Resolution to CRC16 comments

Alon Regev, Ixia

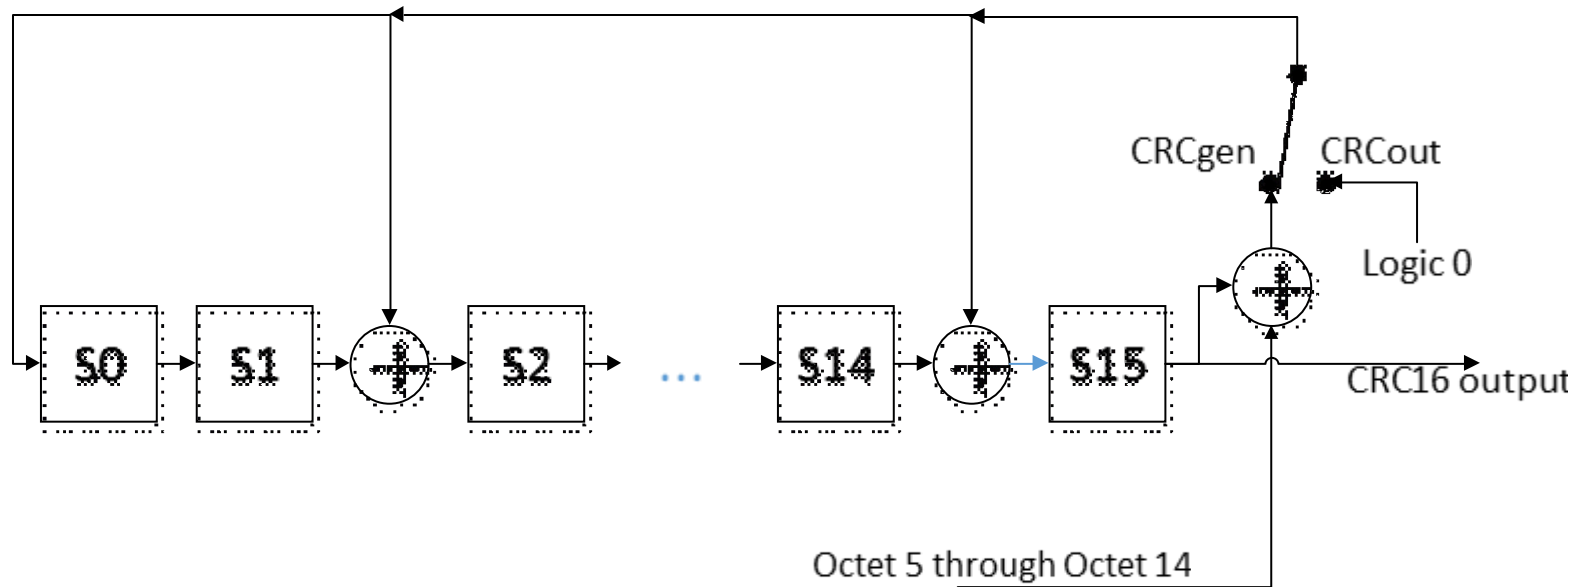
Edit figure 126-25 to show switch as below:
